ADDENDUM #002

DATE: MAY 7, 2024

ELKHORN PUBLIC SCHOOLS
ELKHORN HIGH SCHOOL
AUDITORIUM RENOVATIONS
1401 VETERANS DRIVE; ELKHORN, NEBRASKA 68022

JJA PROJECT: 3626
DRAWINGS & SPECIFICATIONS
DATED: 04/15/2024

Refer to Drawing E3.5– Lighting Elevations and attached revised sheet.

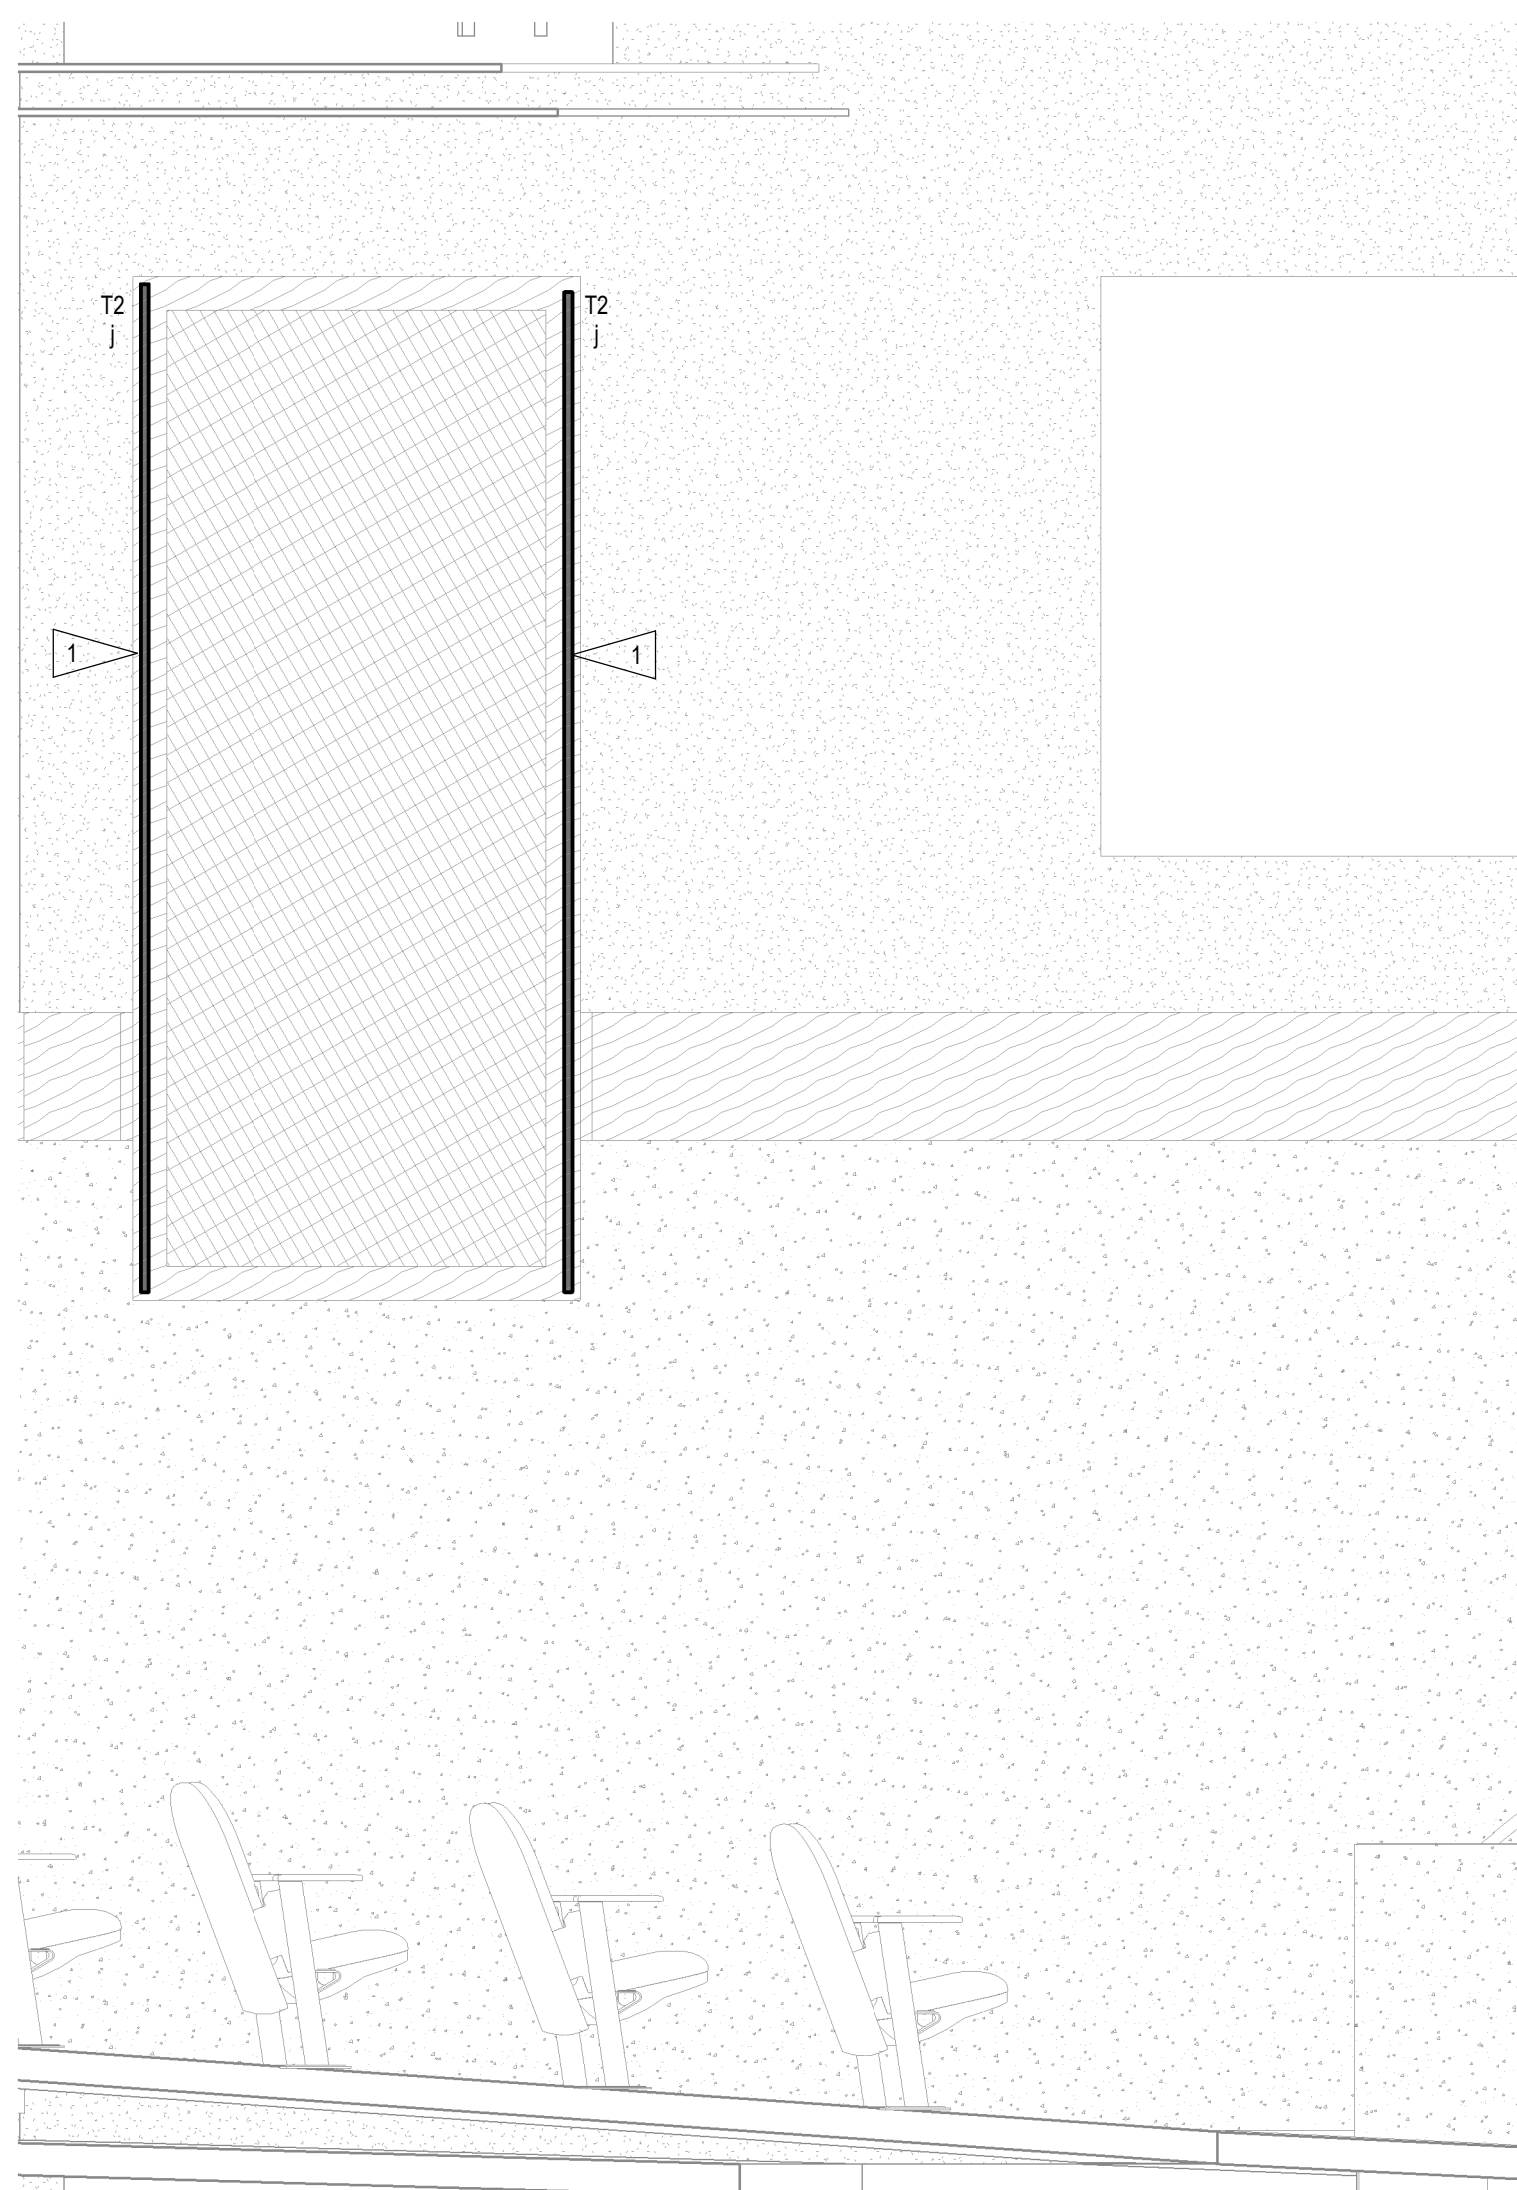
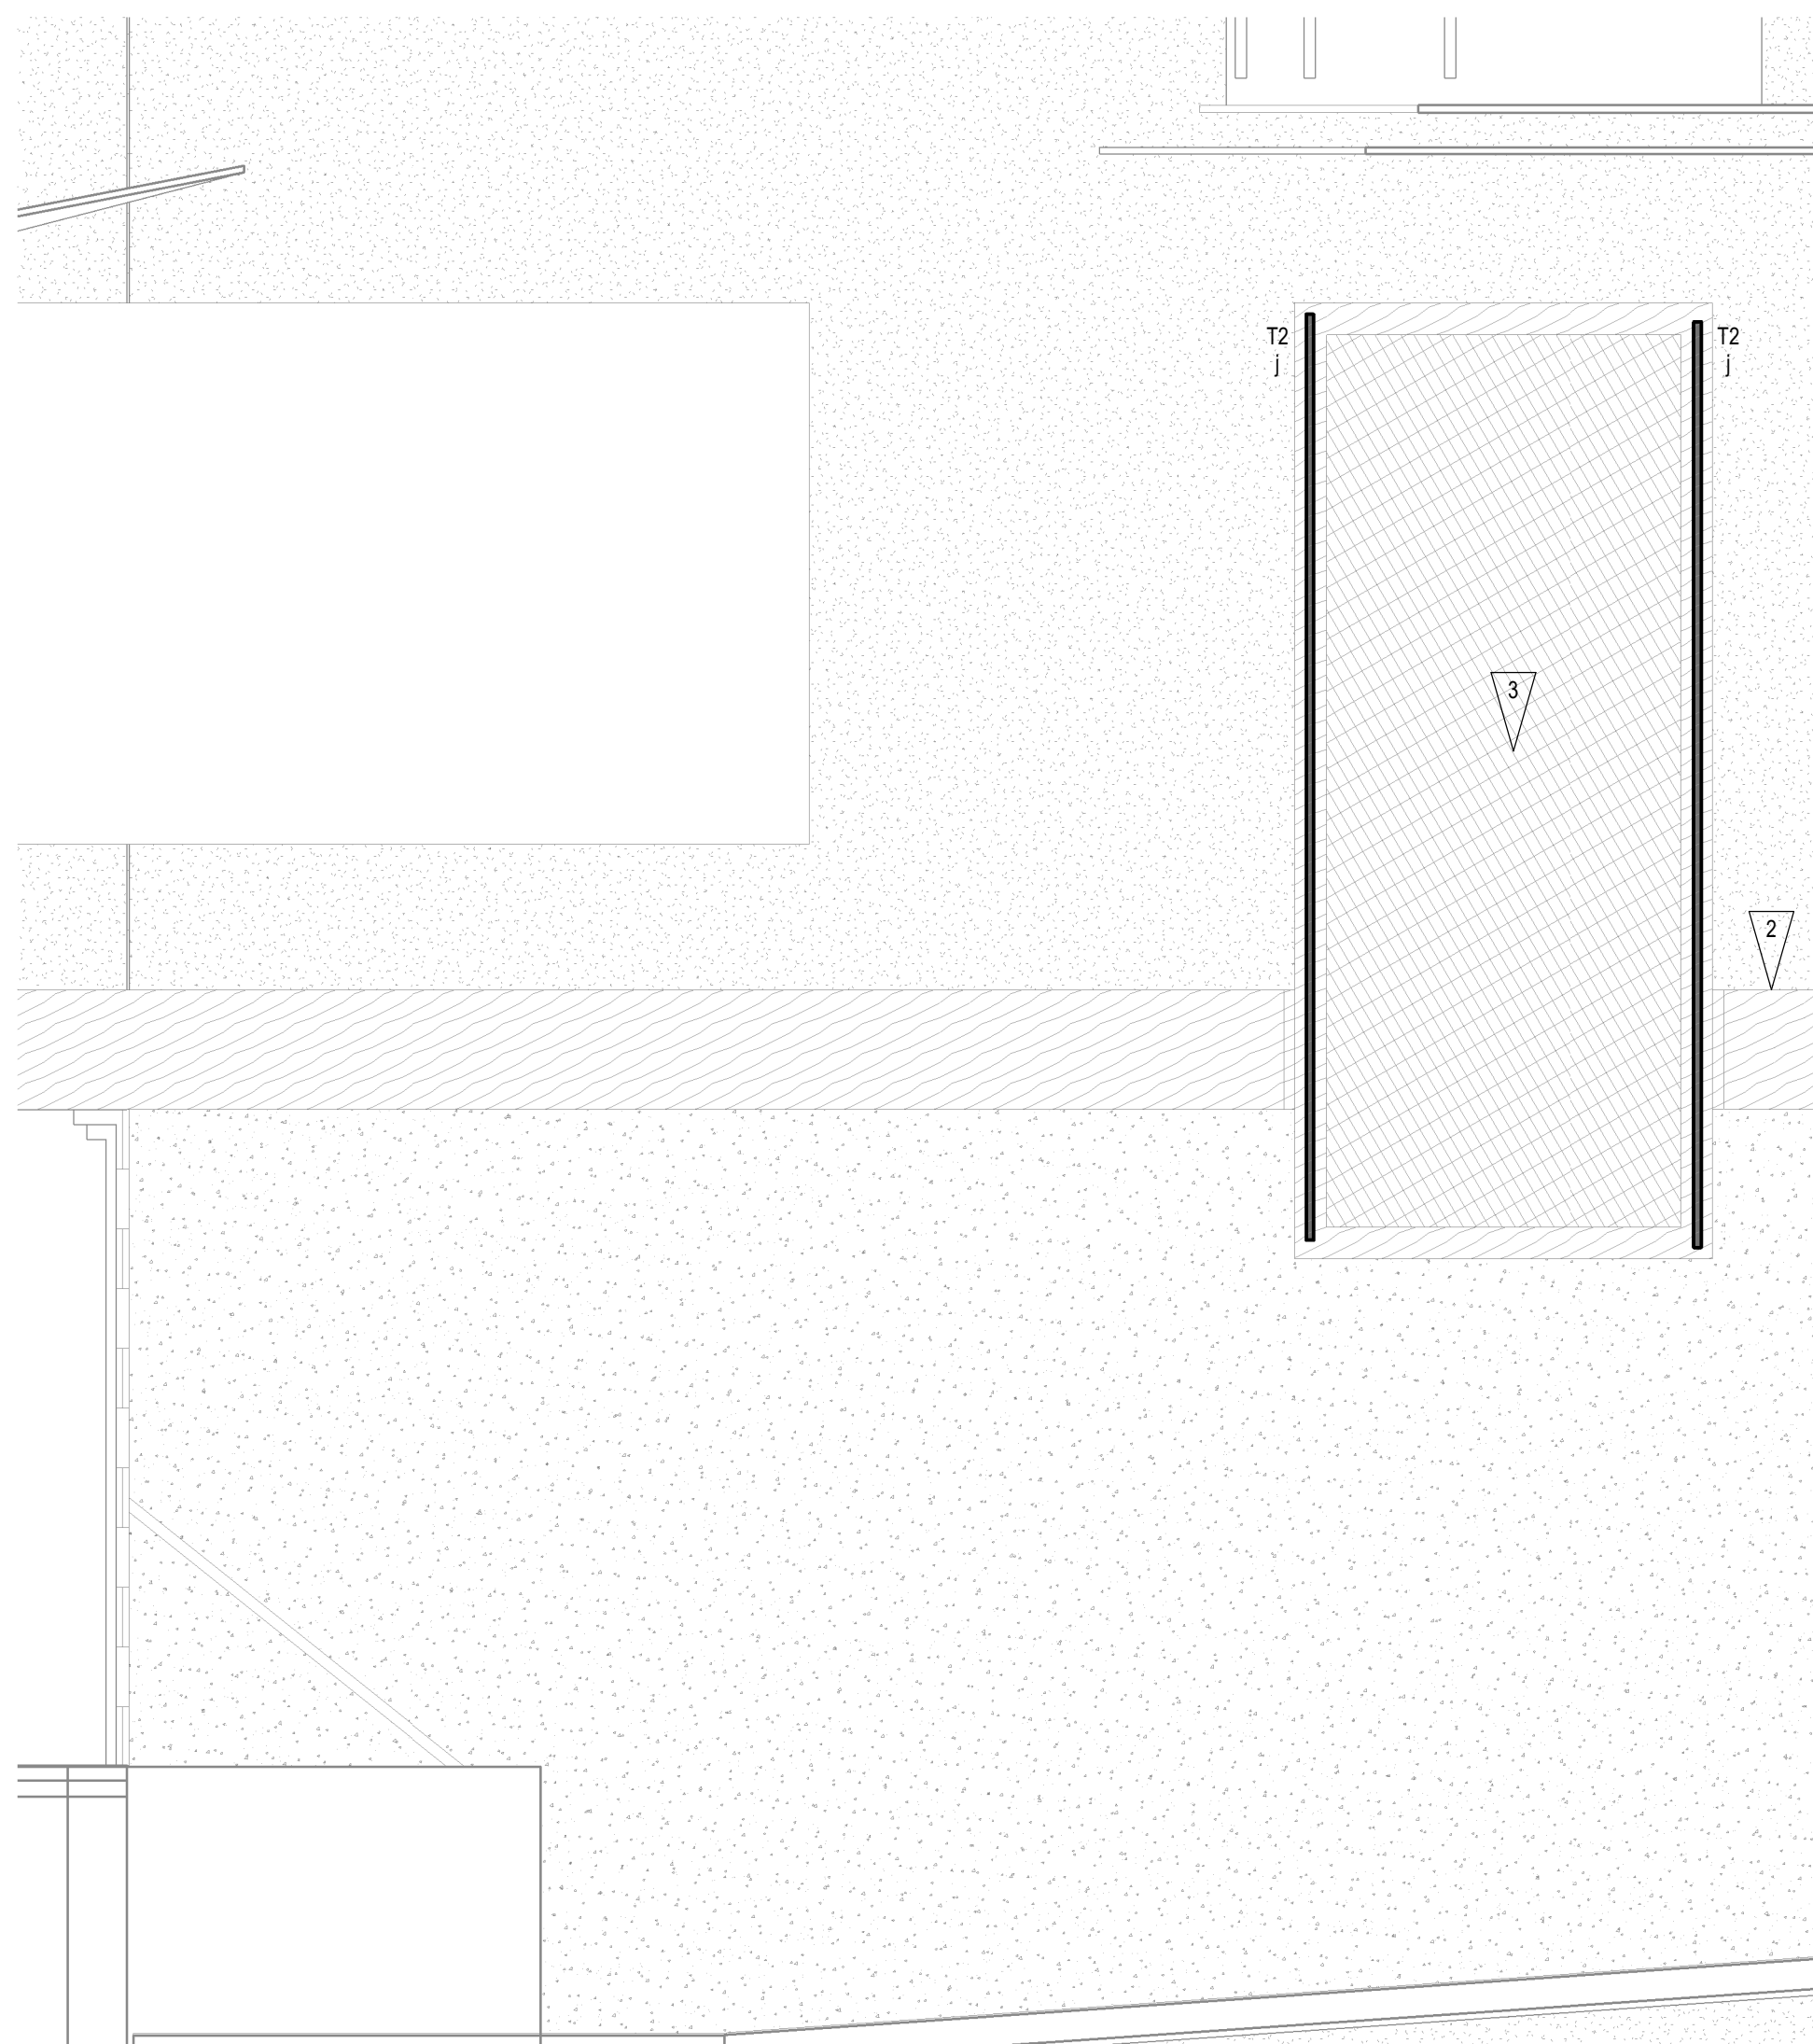
- A. Modify graphic scales for clarification.
